SPORTS VILLAGE AT LAKE NONA

SUMMARY

MASTER PLAN ANALYSIS

The applicant is proposing a Specific Parcel Master Plan (SPMP) to develop four lots consisting of two office buildings totaling 18,877 square feet, two 50,000 square feet office/showroom buildings, 23,750 square feet of ancillary building, and 6 private athletic fields.

PROPOSED DEVELOPMENT PLAN

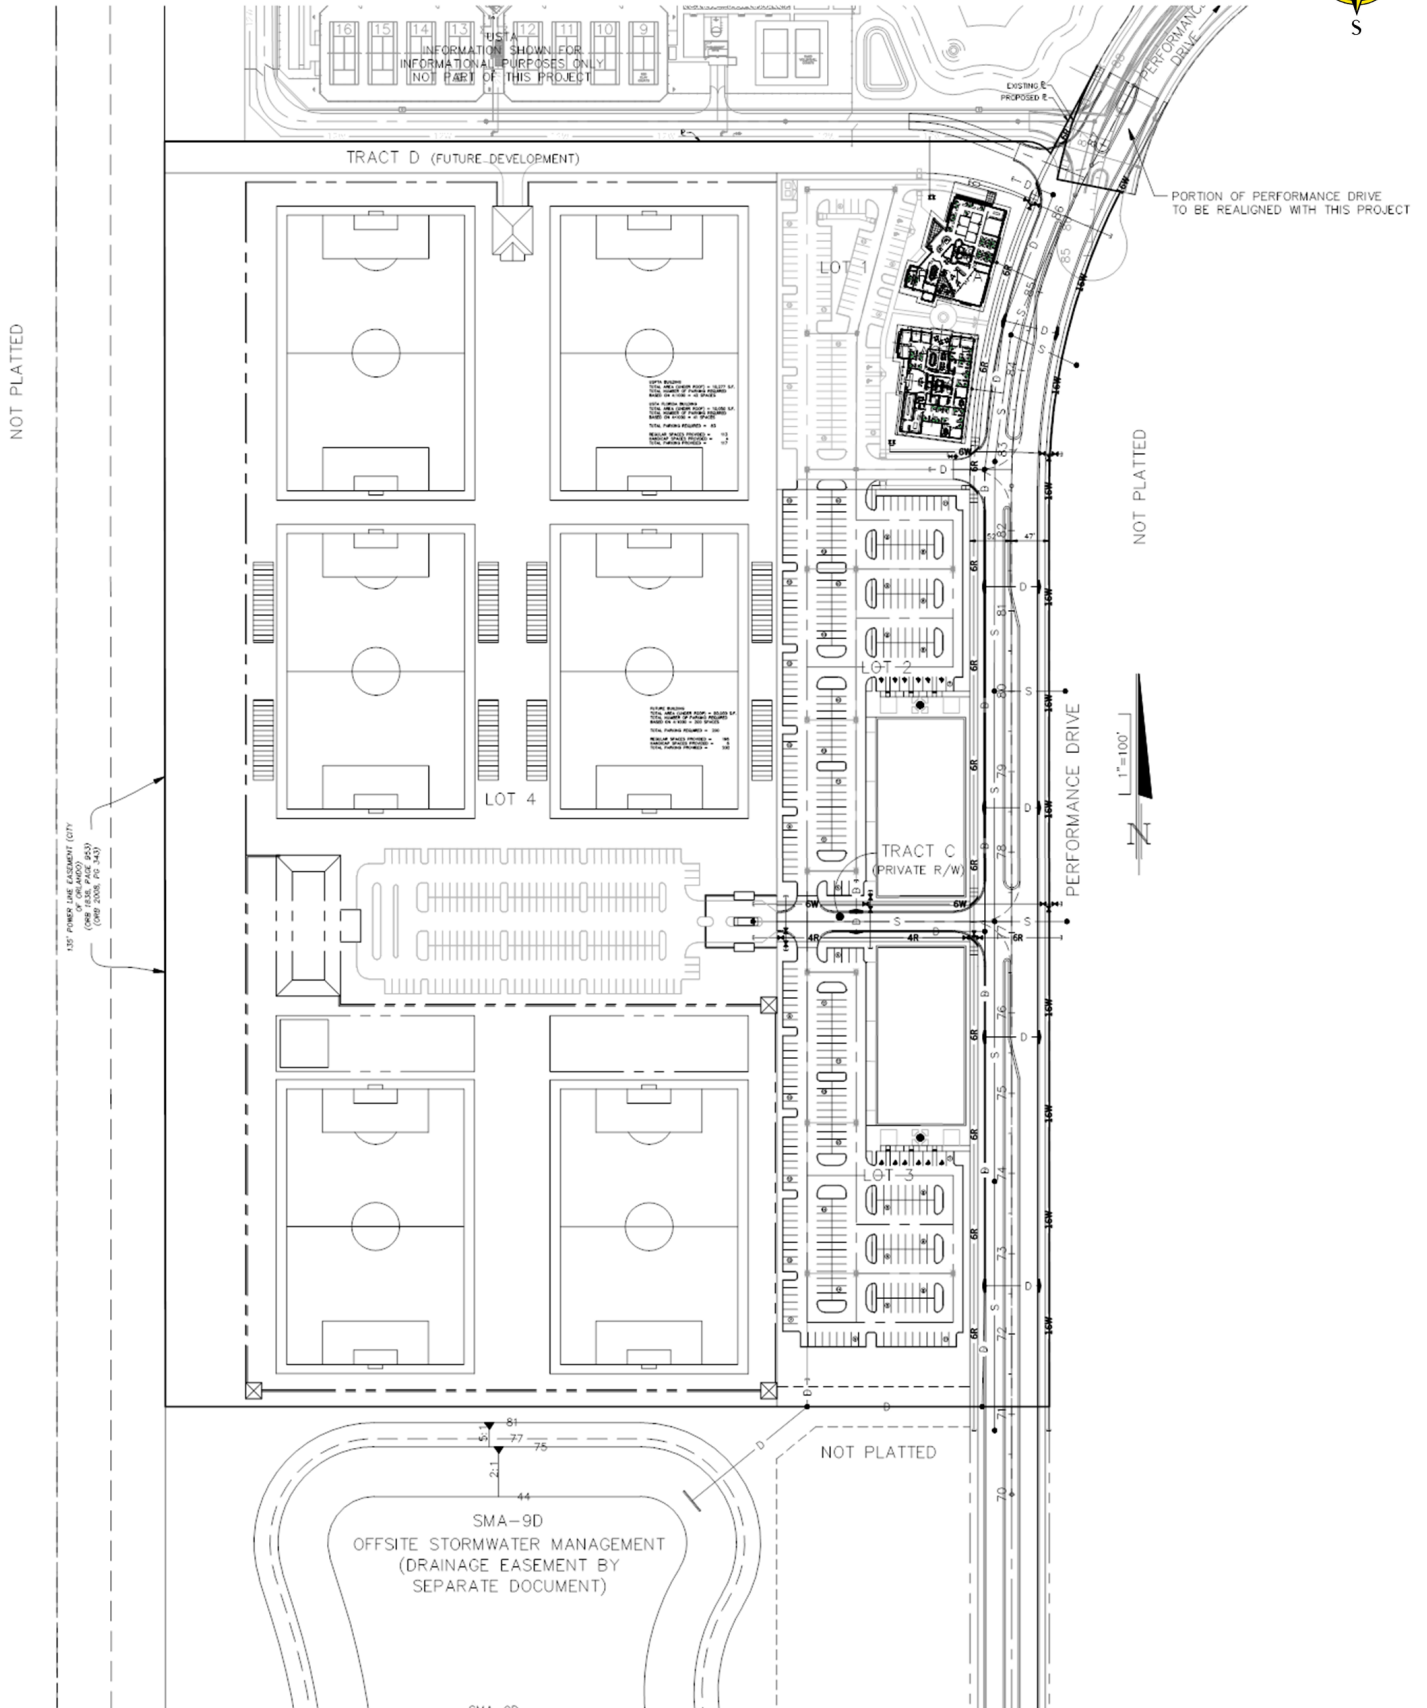
The site plan submitted by the applicant shows two entry roads from Performance Drive and cross access between parking lots.

The site plan submitted by the applicant does not show the locations of any short-term bicycle parking spaces. Per City Code Sec 61.333, five (5) short-term bike parking spaces shall be installed for each building on Tract A & Tract B. The racks shall conform to City standards and be located on an impervious surface so as not to interfere with pedestrian or other vehicular movements. Bike parking shall be provided at the time of construction for all development on Lots 2, 3 & 4 in the ratios required by City Code for the specific land use.

The applicant has requested 117 spaces for Lot 1 although 115 are shown on the plans. Either number is more than 50% above the number of spaces allowed by Code. To allow this overage, City Staff requires a letter from the Applicant/Owner giving an explanation of the need for these extra spaces and the estimated frequency of their use. The Applicant/Owner shall also meet all parking Lot design requirements of Sec. 68.322 – 324 and use SOUTHEAST ORLANDO SECTOR PLAN DEVELOPMENT GUIDELINES AND STANDARDS to develop a design for the parking area that provides additional well shaded pedestrian pathways and seating areas in the parking area and enhanced landscaping demonstrating superior design as required for PD approval.

Need to provide additional plans showing the limits of the road extension with terminus of the roadway shown, along with the balance of the proposed offsite stormwater management tract.

Per City Code Sec 61.333, five (5) short-term bike parking spaces shall be installed for each building on Tract A & Tract B. The racks shall conform to City standards and be located on an impervious surface so as not to interfere with pedestrian or other vehicular movements. Bike parking shall be provided at the time of construction for all development on Lots 2, 3 & 4 in the ratios required by City Code for the specific land use.

TRACT A: USPTA OFFICE BUILDING ELEVATIONS

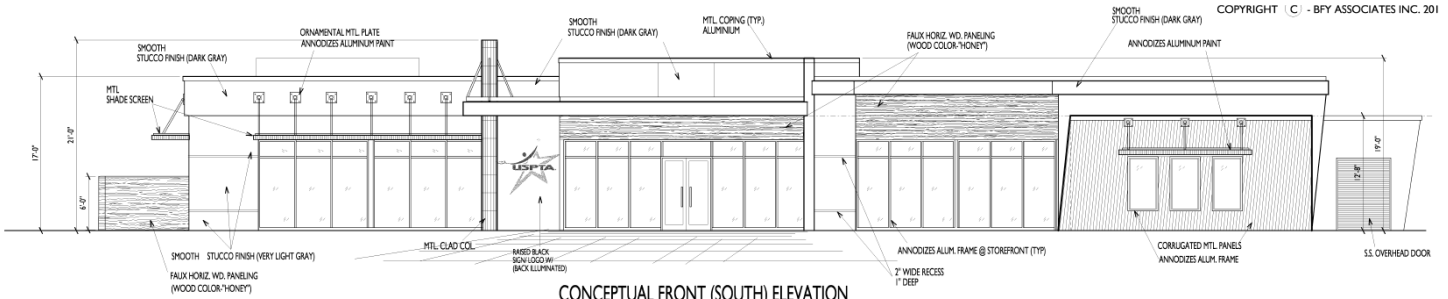
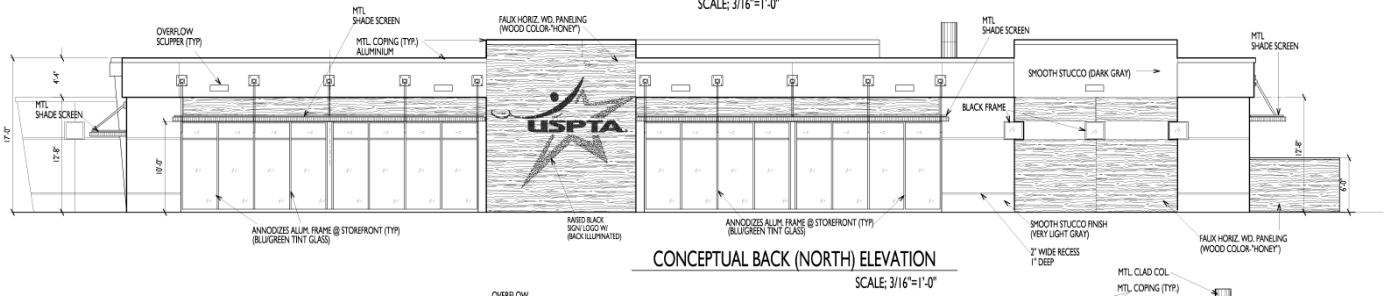
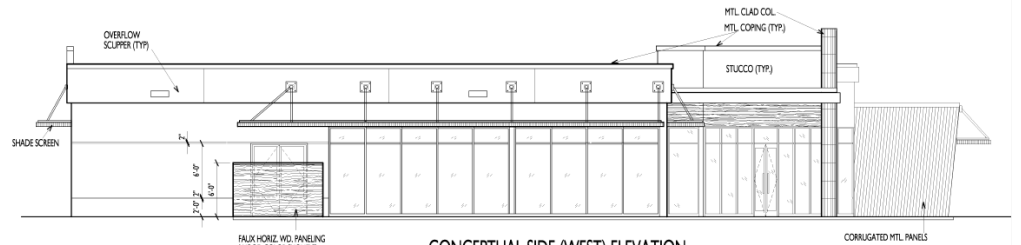
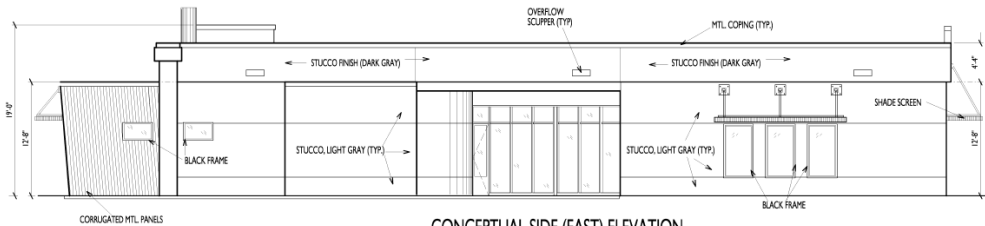
The applicant has submitted building elevations for the USPTA and USTA office buildings on Lot 1. These elevations (on pages 11 and 13) are acceptable. Prior to submittal of building permits for Lots 2, 3, and 4, the applicant shall electronically submit a request for a Planning Official Determination that includes a site plan, elevations for all four sides of each building, transparency calculations, and any other information needed to demonstrate compliance with the conditions of this report and the Southeast Sector Plan.

CONCEPTUAL ELEVATIONS FOR LOTS 2 & 3*

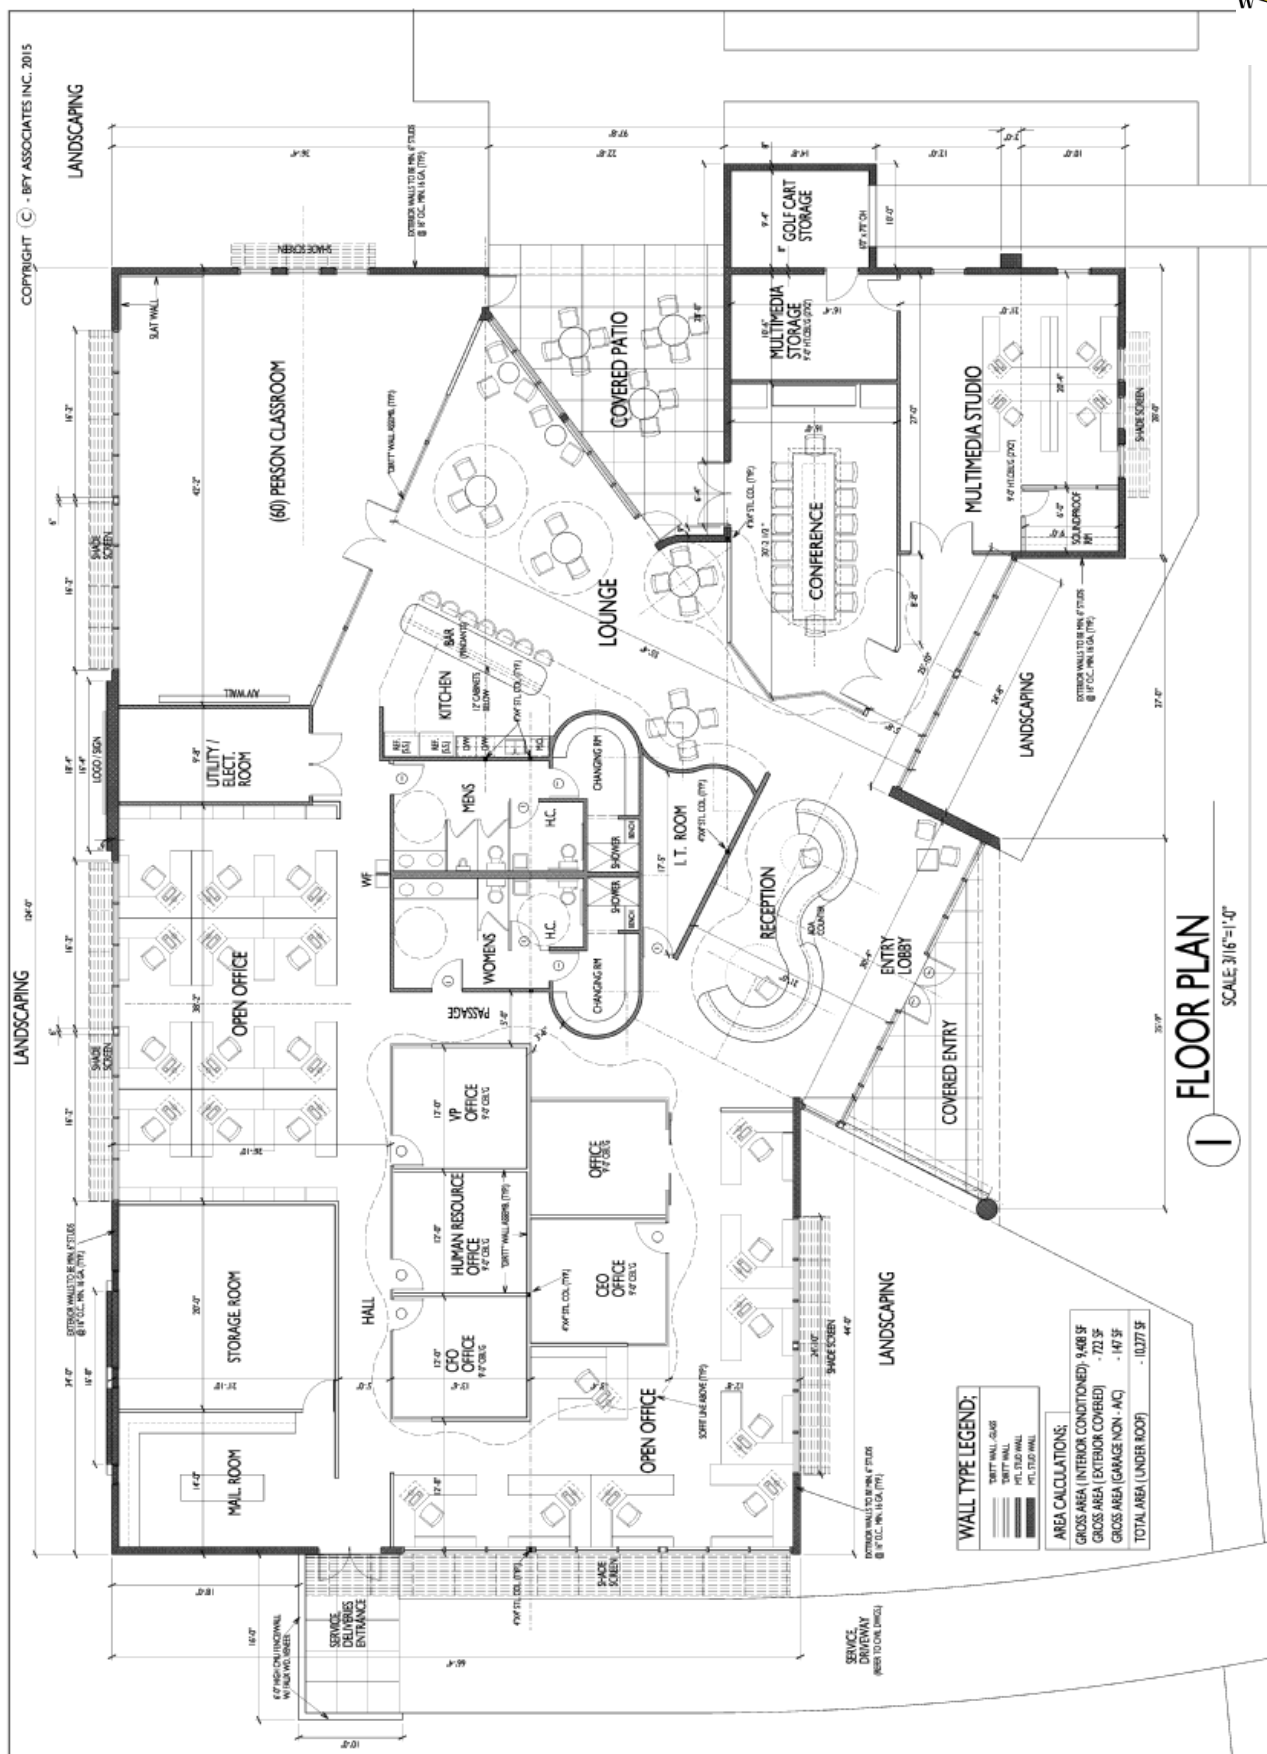
*will require approval through
Planning Official Determination

Building elevations for lots 2, 3, 4 and Landscape Plan for all lots will be subject to appearance review that is approved via a Planning Official Determination. Prior to submittal of building permits, the applicant shall electronically submit a request for a Planning Official Determination that includes a site plan, elevations for all four sides of each building, transparency calculations, and any other information needed to demonstrate compliance with the conditions of this report and the Southeast Sector Plan.

PROPOSED MONUMENT SIGN LOCATIONS

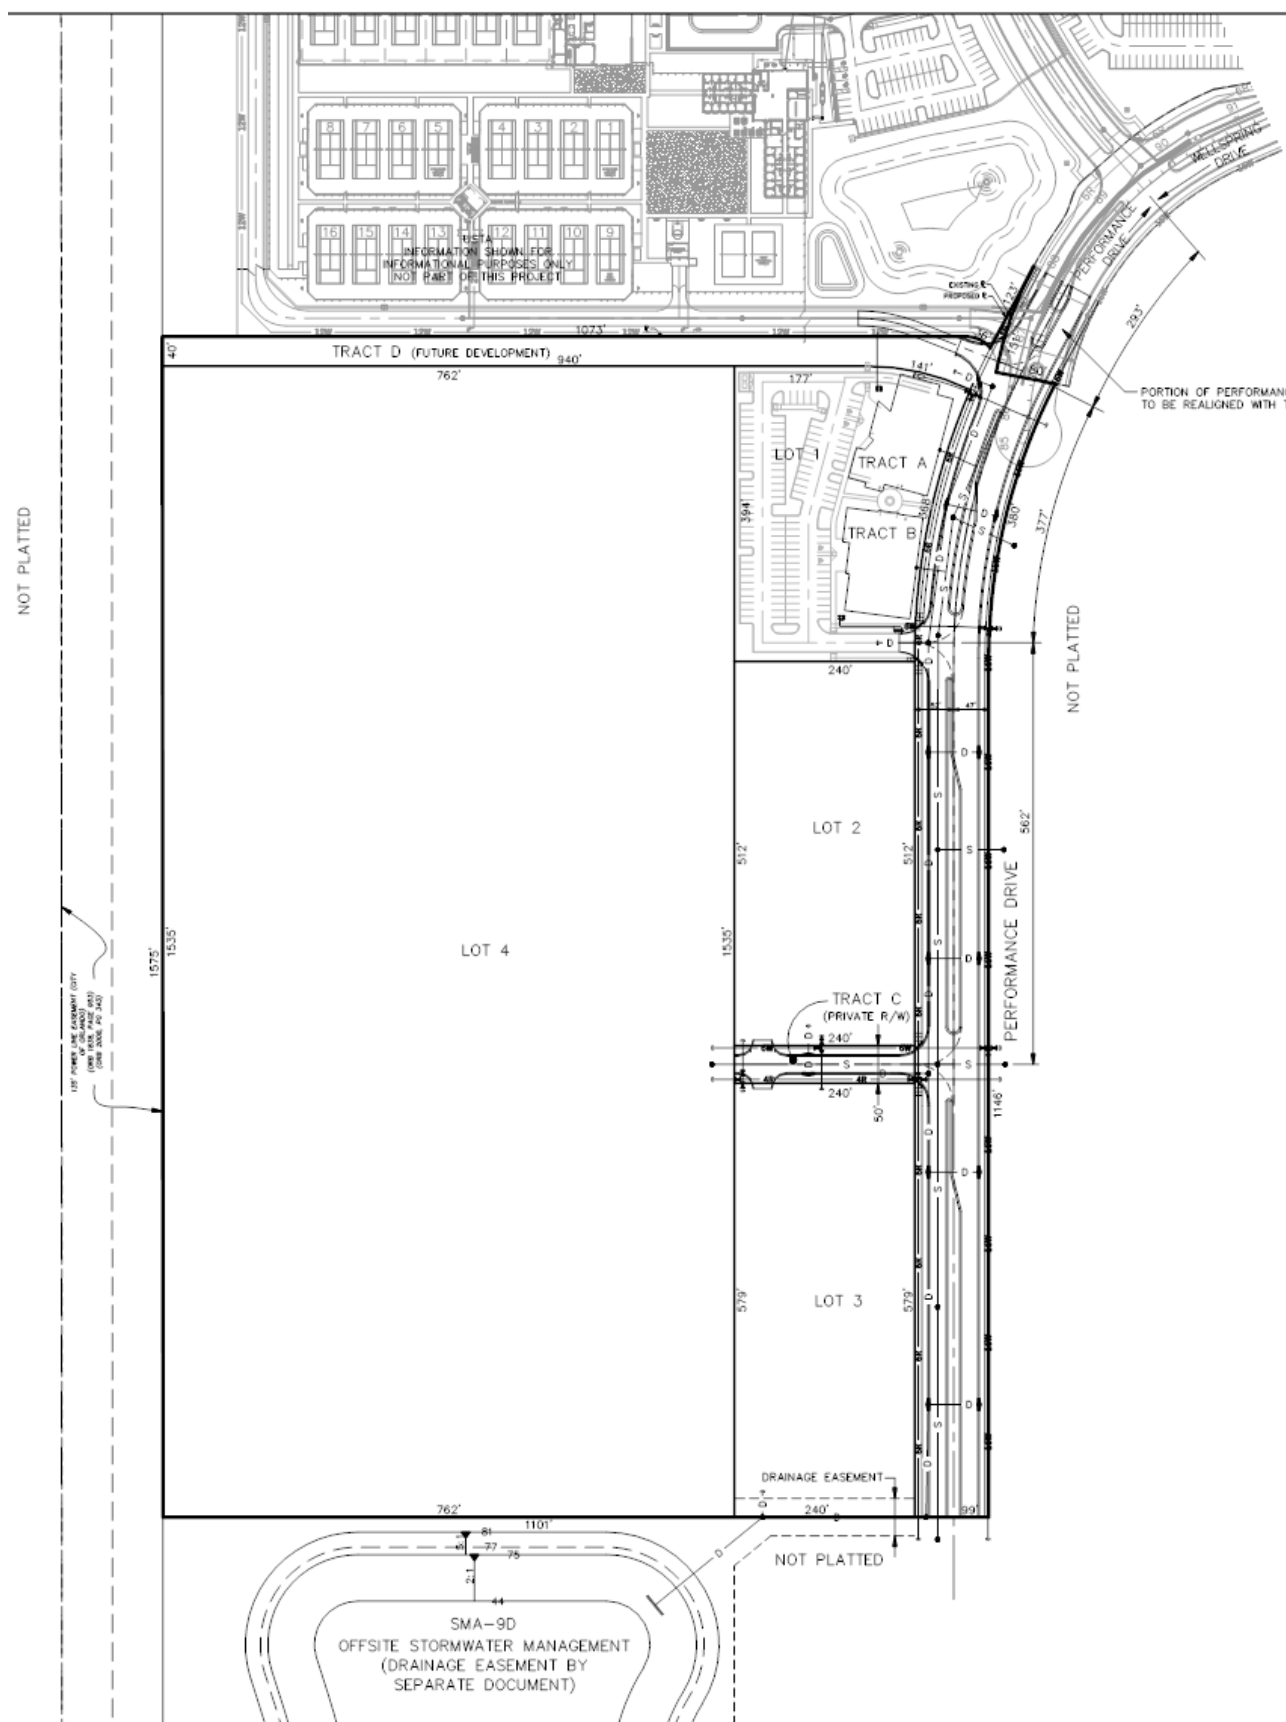
The applicant has submitted a plan that shows the locations of monument signage throughout the property (see page 17). A complete signage package will be subject to Appearance Review prior to the issuance of building permits and shall comply with Chapter 64 of the LDC.

A complete signage package will be subject to Appearance Review prior to the issuance of building permits and shall comply with Chapter 64 of the LDC.
